Re: Hwy. 427 at Rexdale Blvd.,
W.P. #126-60 Site #37-982
Highway #427 District #6

We have reviewed the final bridge plan drawings (Drawing #1,3 and 6) dated February, 1978 for the above mentioned structure and submit the following comments.

Hwy. 427 Underpass at
Rexdale Blvd.
Dist. 6, Toronto
W.P. 126-60 Site 37-982

FOUNDATION INVESTIGATION REPORT
For
The Proposed Underpass Structure
At the Crossing of Hwy. #427 and
Rexdale Blvd.,
Borough of Etobicoke, County of York
District No. 6 (Toronto)
W.O. 72-11024 -- W.P. 126-60

DATE BY		DESCRIPTION	
DESIGN GA	CHECK	LOADING HS 20-44	DATE FEB 78
DRAWING A	CHECK JB	SITE No 37-882	DWG 1

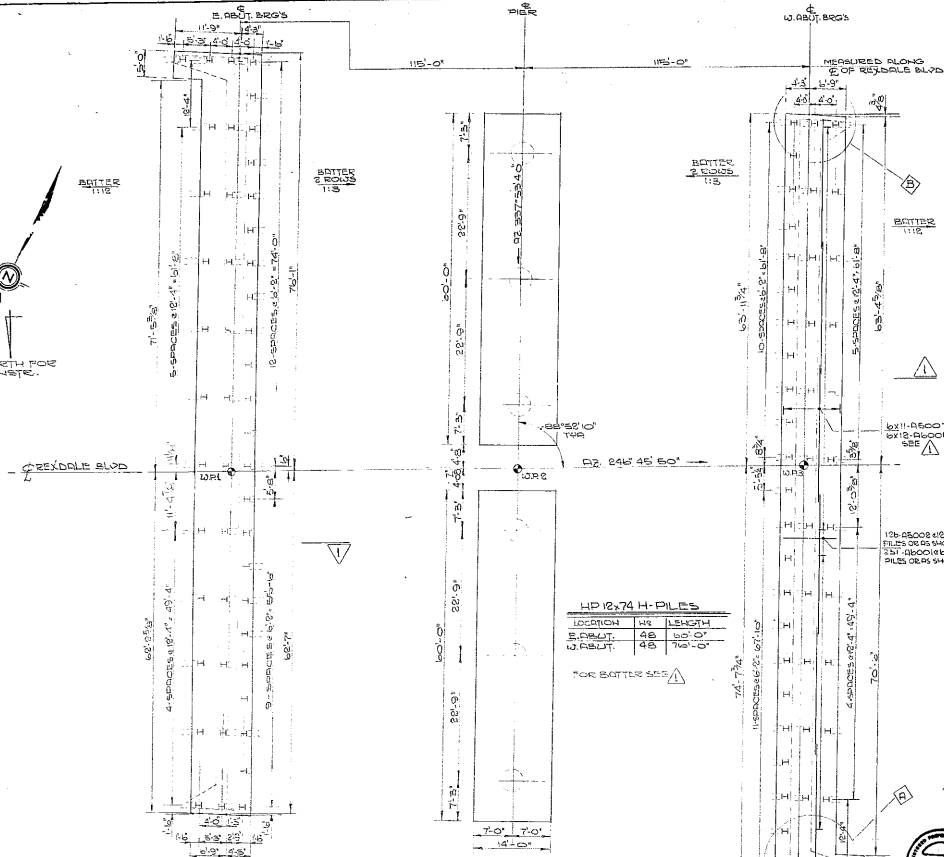
1. According to the final plan drawing the center pier is founded on spread footings. However, as recommended in our letter dated November 1, 1977, we believe that in order to allow a safe design load of 3 t.s.f., the base of the footings should be placed at or below elevation 530.0 (Ref.B.H 8 & 9).
2. In our letter dated November 1, 1977 we recommended to support the abutments on natural subsoil at elevation 540.0 and use 2.0 t.s.f. safe bearing value. Alternatively, we recommended a #14 timber pile driven to elevation about 490.0 with a safe load of 25.0 tons/pile. According to the final plan drawing the abutments are supported on 12 HP 74 steel H-piles driven to bedrock. However, the final choice should be based on economic or other necessitating considerations.
